Specification change of the rating plate label

We would like to inform that we will change the rating plate label of automatic power factor controller.

VAR-6A,VAR-12A

Example of VAR-6A.

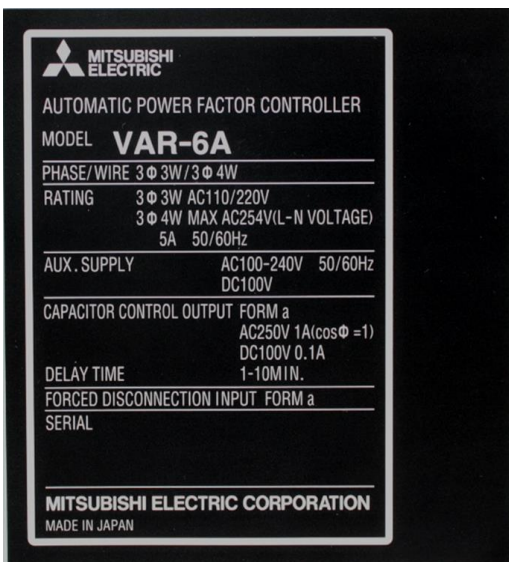
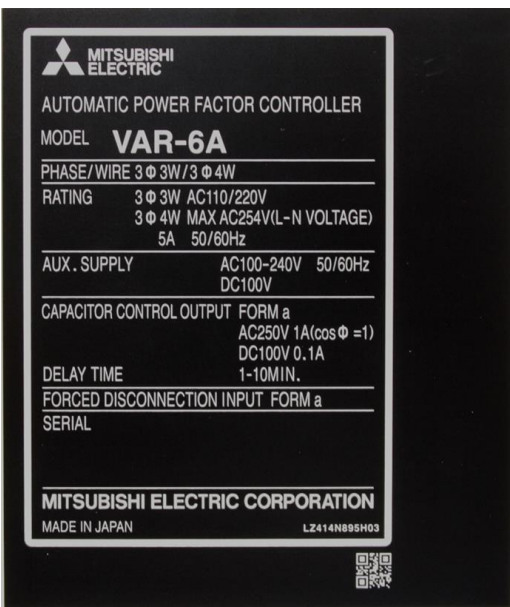
Item	Before change	After change
Outward Appearance		 <div style="text-align: right; margin-top: 10px;">  </div>
Label Size	H79mm×W72mm	H85mm×W72mm

Add QR code

※There is no change in the label items.

To strengthen traceability.
